Application Reference: P/23/00822/F
Address: Canford Resource Park, Arena Way, Magna Road, BH21 3BW
Proposal: Demolition and Removal of existing structures and the erection of a Carbon Capture Retrofit Ready Energy from Waste Combined Heat and Power Facility with associated Combined Heat and Power Connection, Distribution Network Connection and Temporary Construction Compounds and associated buildings and ancillary car parking.
Case Officer: Senjuti Manna

Objection to APP/23/00822/F

Figure 4-7: Preliminary EfW CHP Facility Site layout

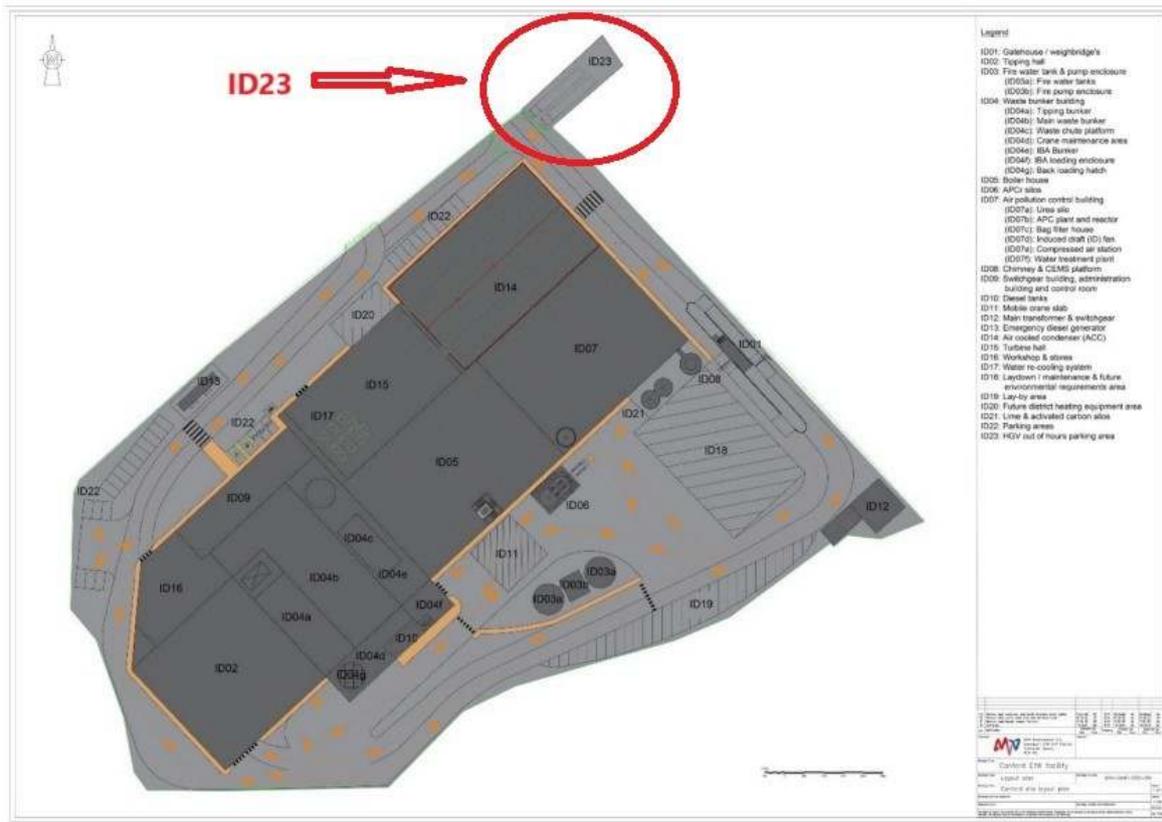
It is evident that the amount of space allocated is wholly inadequate and offers no serious option of retrofitting a CCS, a point made by the Secretary of State for Housing, Communities & Local Government in her judgement on the Powerfuel (Portland EfW) appeal of 16th September, 2024:

The land in question appears to be around 900 square metres in area which is a fraction of what would be required for a CCS facility serving an ERF of the scale proposed. (Para 8.64)

it is hard to see how a retro-fitted CCS can be accommodated within the current application site or how the site could be extended without being in breach of current planning guidance.

1. A detailed and feasible site plan showing the full CCS infrastructure's footprint, demonstrating that there is adequate space within the site allocated by the BCPD Waste Plan.
2. An updated air quality assessment to account for new emissions from the CCS process, including potential amine emissions.
3. A revised biodiversity impact assessment considering additional land requirements and operational effects, such as habitat loss, disturbance and damage.
4. An updated hydrological and ecological impact assessment, with full analysis of projected water use and contamination risks.
5. A thorough analysis of the traffic impact of the transportation of liquid carbon.
